# Submission on Draft Ingleburn Structure Plan

Ingleburn Chamber of Commerce & Industry Inc.

6 February 2015

**Figure 1 Creation of two separate high density areas away from Oxford Road**

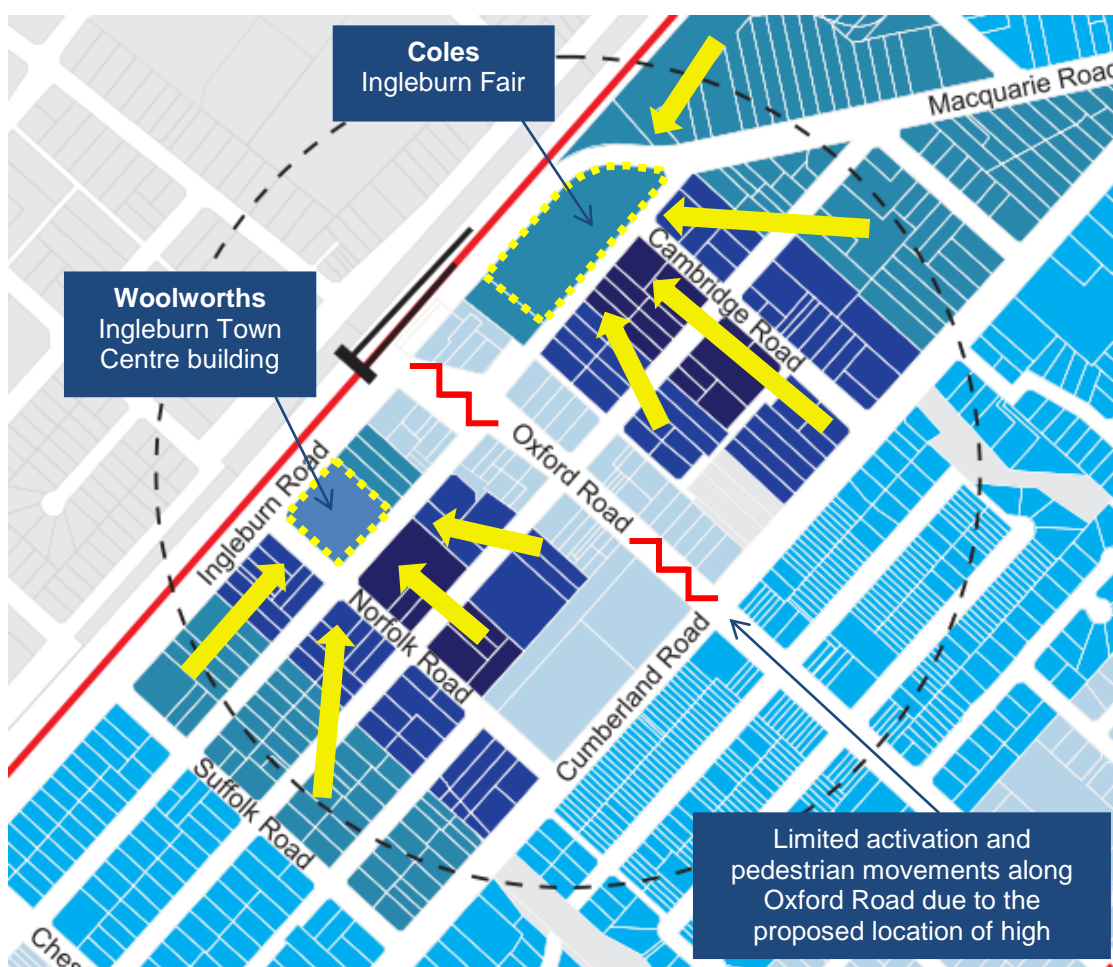
Residents living within the future higher density areas set well back from Oxford Road are more likely to utilise the closest services to their home. Based on the layout of Ingleburn with these two anchor stores and the proposed location of higher density buildings, the draft Plan if implemented may lead to reduced movement along Oxford Road. The draft Plan could be seen to promote a separation of Ingleburn Centre with pedestrian movements anticipated along the side streets (Norfolk and Cambridge Street) – refer to **Figure 1**.

The draft Plan needs to be reviewed to better achieve the rejuvenation of Oxford Road and the core of Ingleburn Centre.

**Figure 10** Cross-rail and open space linkage opportunities

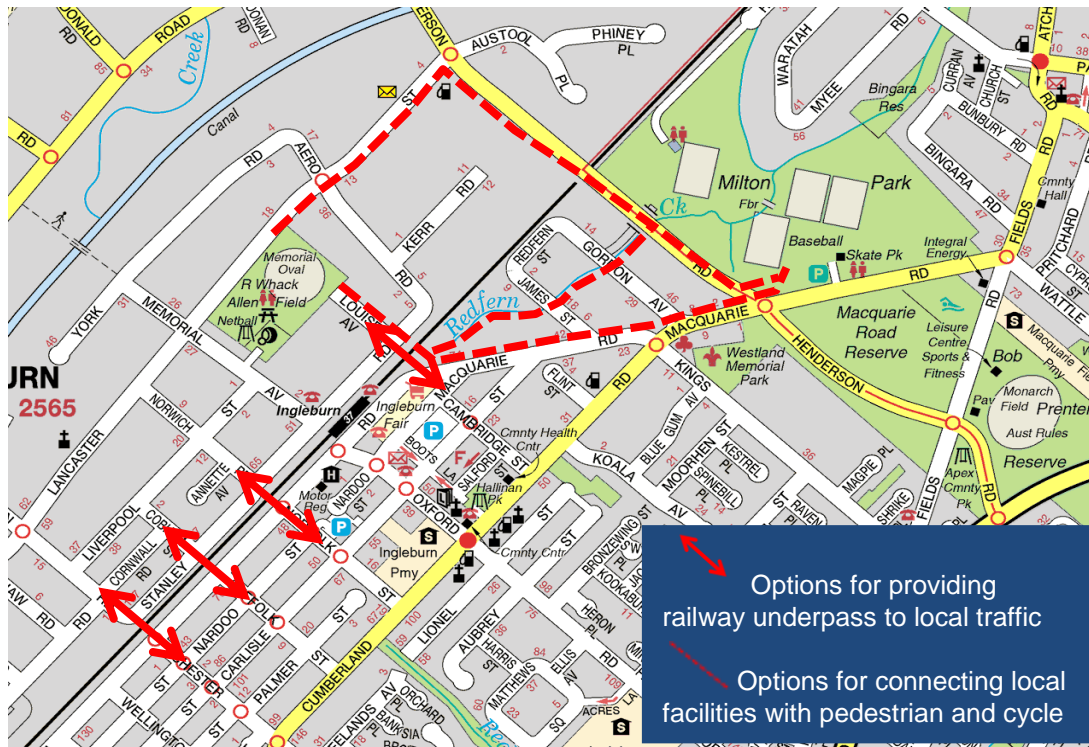
This connection could be provided via a small underground tunnel below the railway line to provide local access to better link these areas. Older examples of this type of link are shown in **Figures 8 and 9**. Noting the location of Memorial Oval on the western side of the railway line, a small local connection would assist in providing links to active and passive open space provision to meet the additional population (**Figure 10**).

It is understood that providing a cross-rail link is not straightforward. There is limited space to provide a new bridge, underpass options potentially have drainage implications, and whatever link that is provided should be designed to enable local access only and avoid a new route for heavy vehicles.

Options for the cross-rail connection, and the funding and delivery of the preferred option(s), should be fully investigated as part of the next phase of planning for the Ingleburn Centre.
